#### **Executive Director's Recommendation**

PROJECT Cobb Park 200 H Street, NW

8379

Approval of preliminary site development plans

# Proposed Plan

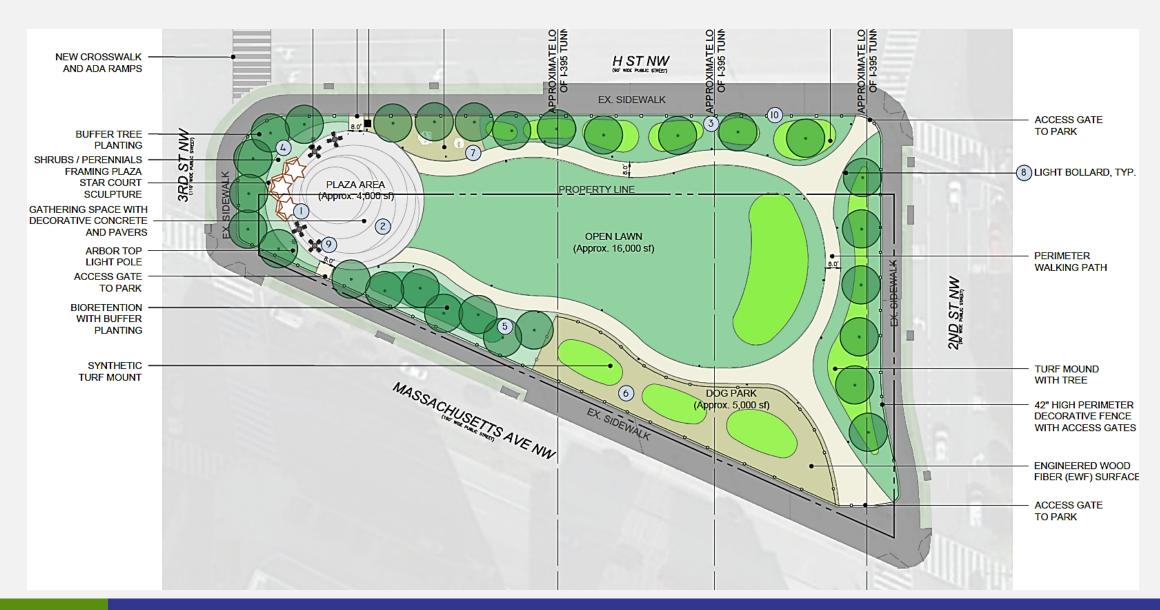
**Recommends** the applicant explore the incorporation of additional trees or other shade elements to help improve visitor comfort.

**Requests** the applicant coordinate the necessary stormwater management on the site with the District Department of Energy and Environment and consider approaches that can be integrated with the landscape design.

**Requests** the applicant coordinate with the District Department of Transportation regarding the use of the public space within the H Street and I-395 rights-of-way.

### Star Court Detail

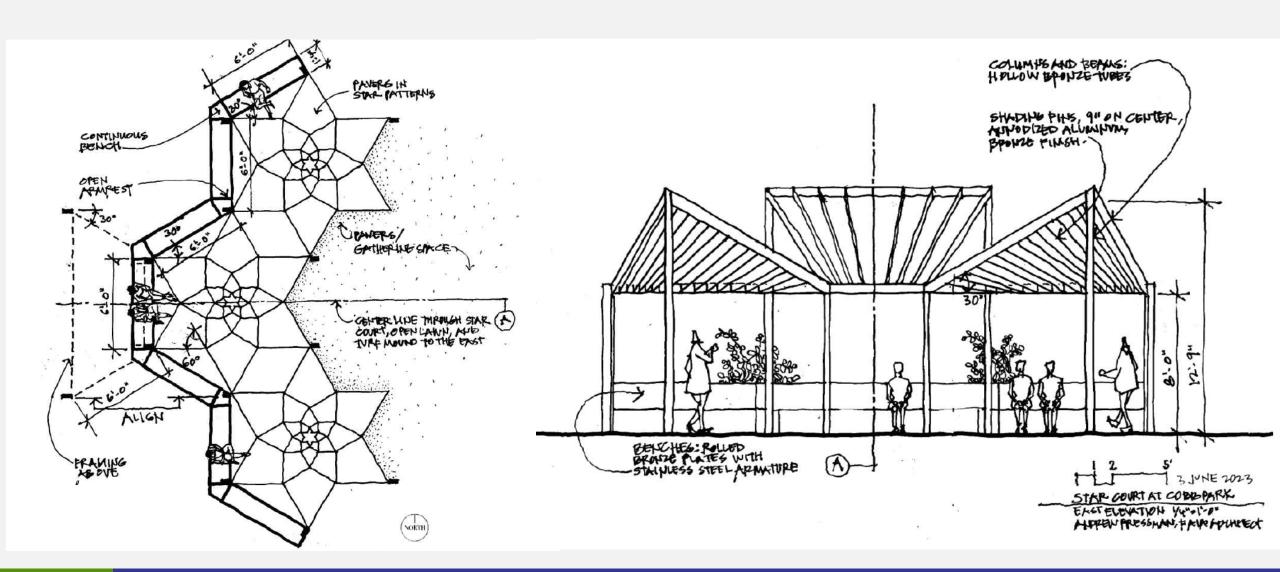
The proposed Star Court art installation is intended to inspire serenity and relaxation in the gathering area. The design of the Star Court is inspired by the neighborhood's namesake, the Mount Vernon Triangle. The geometry of the design is a 6-pointed star made of triangles. The materials for the Star Court include anodized aluminum with a bronze finish, vertical bronze tubes, and a paving pattern that matches the overhead pergola design. The proposal indicates that the seating will be rolled bronze plates over stainless steel armature, but the applicant has indicated that they plan to update these materials to wood to ensure the seats do not overheat in the sun.
